FP/UK/Road/31411/2018

Date -22/09/2020

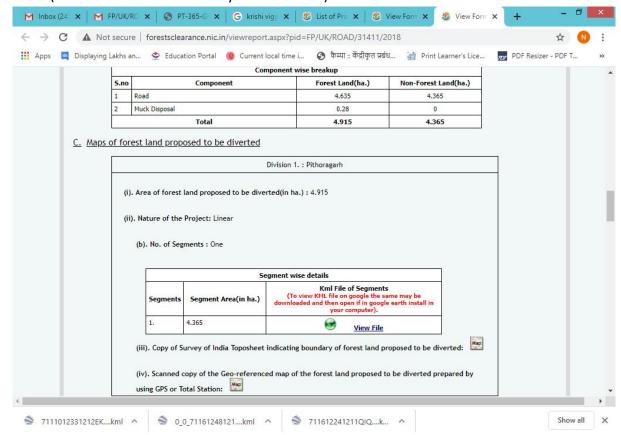
- 1- In Form A, Part I, under D-(a). Copy of map indicating location of alternative examined: No Data is shown, Kindly upload the Map of the alternative location examined.
- 2- The area of segment seek for diversion in Form A, Part I, Under C-Maps of the forest land proposed to be diverted is mentioned as wrong. Kindly rectify the same.(screenshot is attached for your reference).

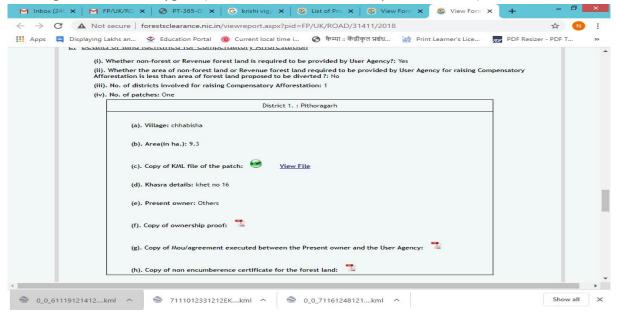
3- The forest land seeks for the diversion is 4.915 ha therefore the CA comes out to be 4.915*2= 9.83 ha but the same has been mentioned as 9.3ha under the L-(iv)-the details of the CA land identified. Kindly clarify the same; also the KML file uploaded at that place not have the polygon laid for the CA area, Kindly upload the KML file by

showing the CA area Polygon. (screenshot is attached for your reference).
